Certificate of Appropriateness

910 N. OLD WORLD THIRD ST. Second Ward Savings Bank

1/11/2017

PTS ID 114186 COA

Drawing No.
A301

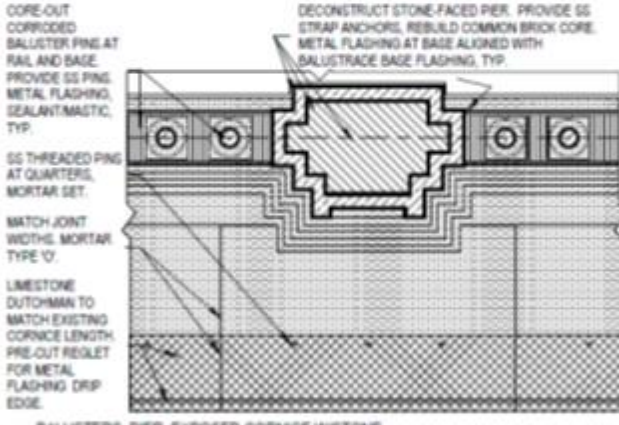
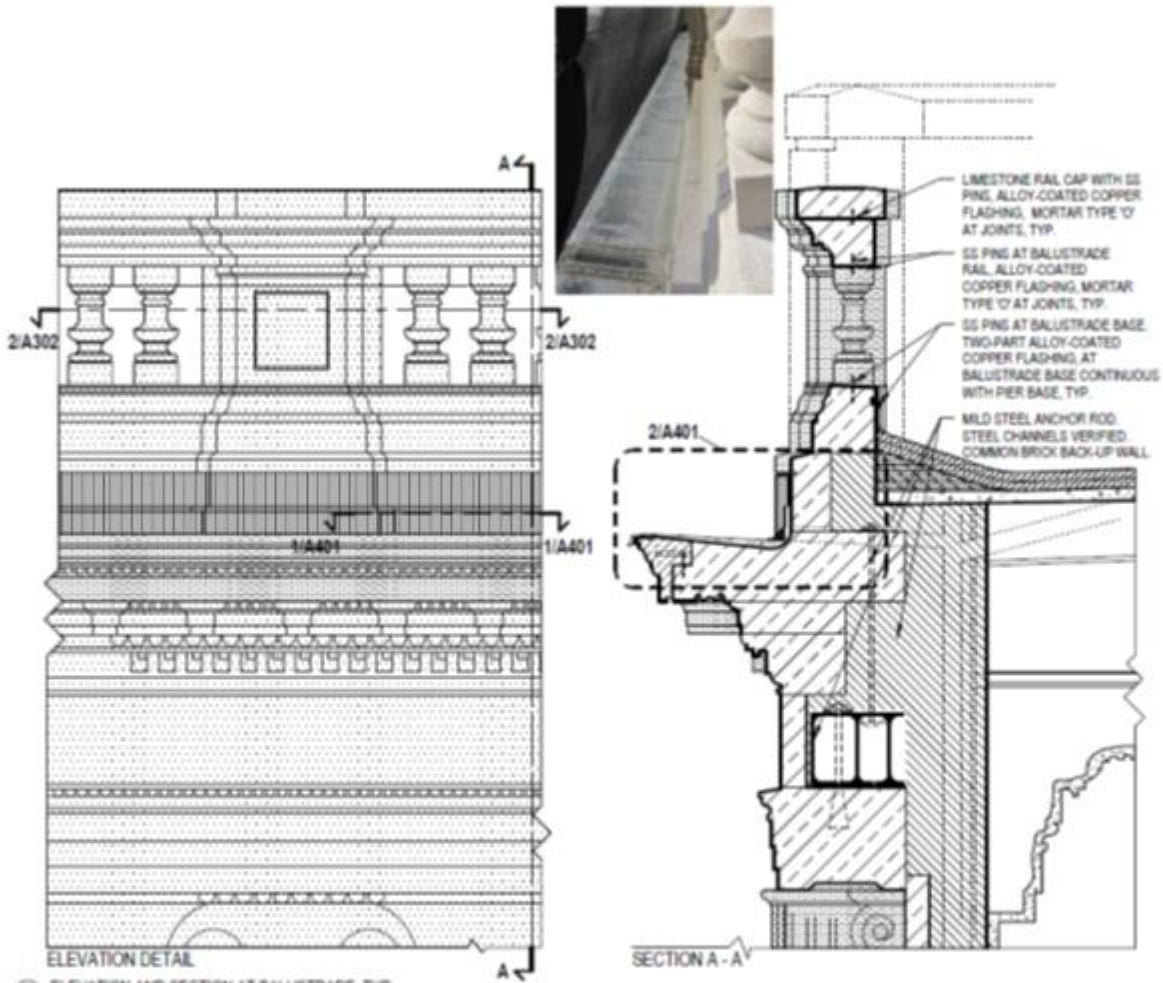
The stone cladding of the solid balustrade will be re-pointed. The previously mortar-set cap stones will be pinned and have new, alloy-coated copper flashing. The balustrade brick back-up walls are protected by metal panels installed on hat channels. Air circulation was verified and so the existing metal panels will remain in place. (1/A301)

assessment of the conditions necessitating the displacement will inform the subsequent stabilization of at least four of the remaining six cartouche assemblies. (Total of seven cartouche.) Alternatively, given that the assembly works as a true arch, a repair-in-place is feasible. Approximated life-span is 25 years. The visual displacement would remain.
(1/A301)

Applicant must provide stone samples to staff before beginning construction. An appropriate historic, high lime content mortar must be used. Photographs of all sides of any baluster or any other stone piece proposed for replacement should be presented to staff for approval before any reproductions are made.

Drawing No.
A302

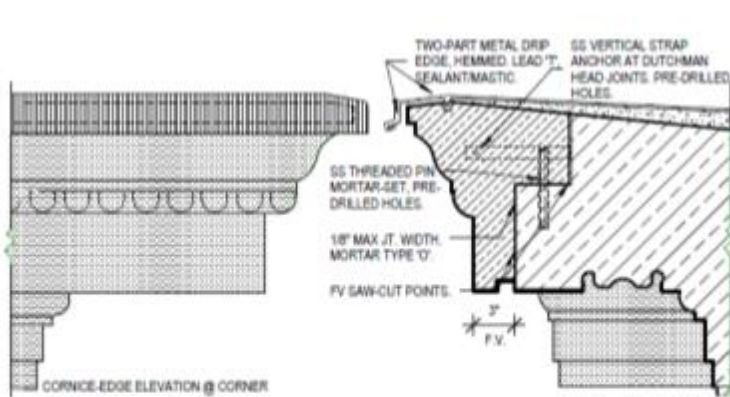
The alloy-coated copper, adopted for the cornice gutter, will also flash the individual pier cap stones, balustrade cap stones and baluster base units (plinth). (1/A302)

A401

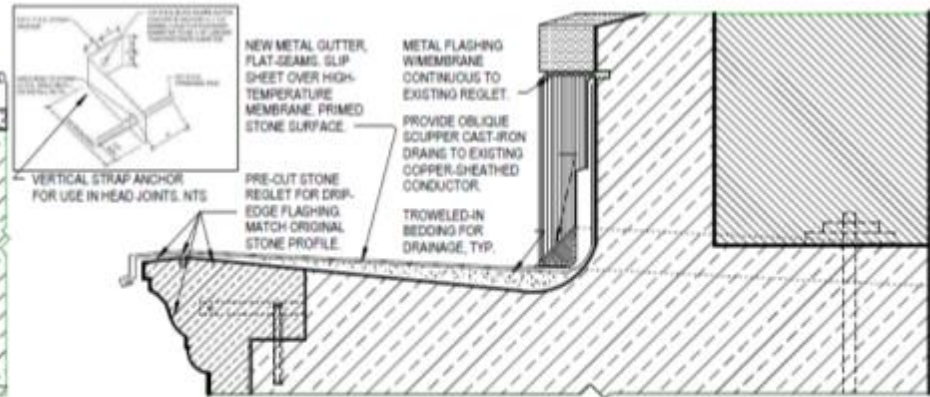
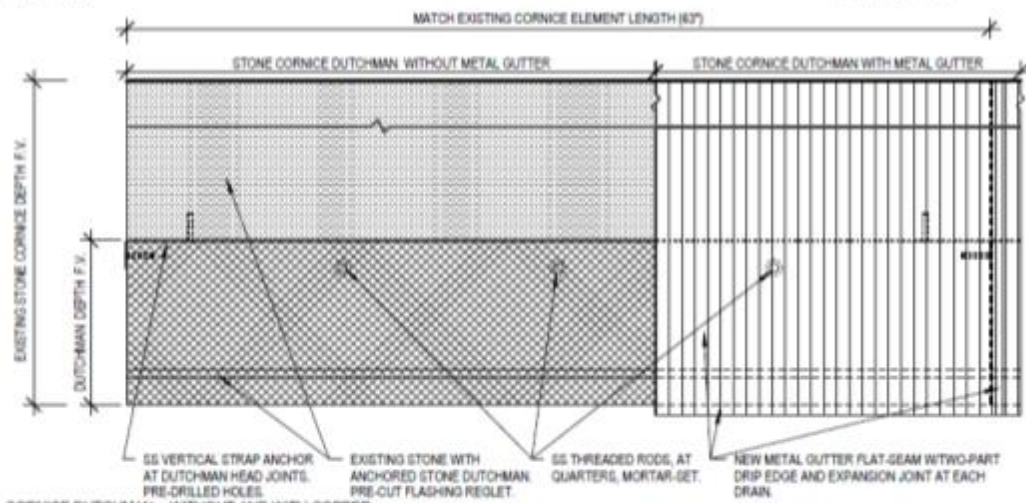
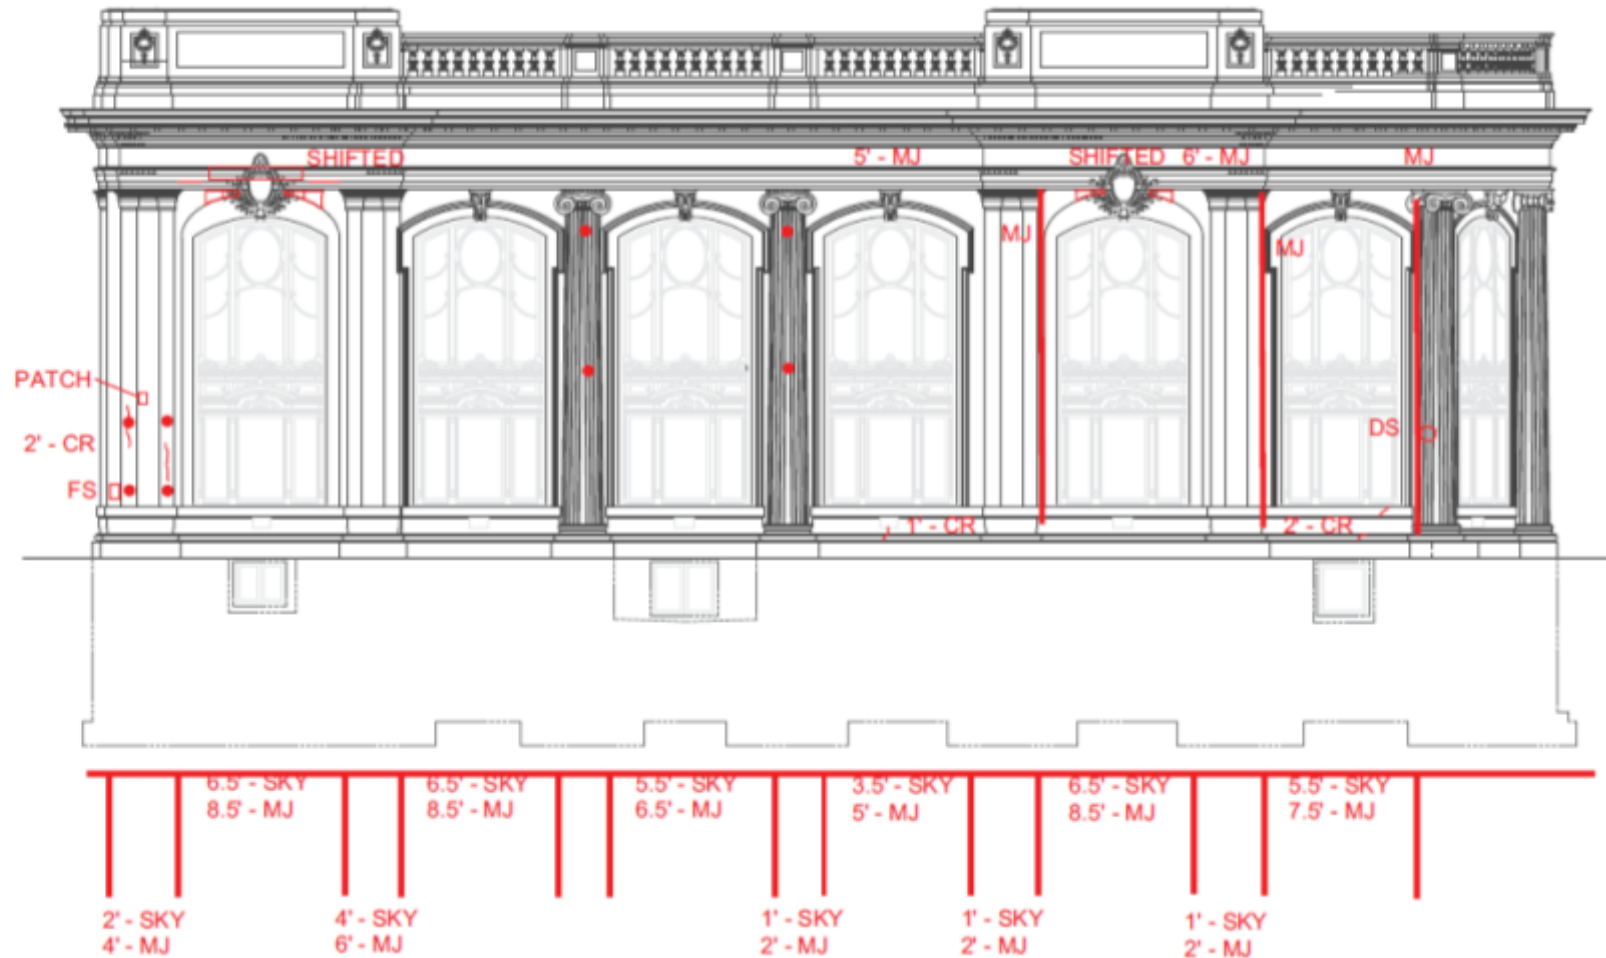
The severely, spalled cornice edge can be repaired by removing the damaged edge. A new piece of stone will be keyed to the existing 7000 lb. limestone unit. This limestone Dutchman method will be utilized at the cornice tip around the entire building perimeter. The new Indiana limestone will have a different patina. It will appear as an imperfect color match to its weathered receiver. (A301, 3/A401)

The existing flashed-in cornice conductor opening will be replaced by sidewall drains to assure efficient drainage. The carved limestone units, below the projecting cornice, will be cleaned of all efflorescence and accumulated dirt and grime. (2/A401)

An alloy-coated copper gutter, flat seamed, will line the entire stone projection from the drip edge to the up-wall flashing. Expansion joints will be installed at the six drain locations. A watertight membrane and complete repointing of the cornice mortar joints will inhibit water infiltration into the wall assembly below. (1/A401)
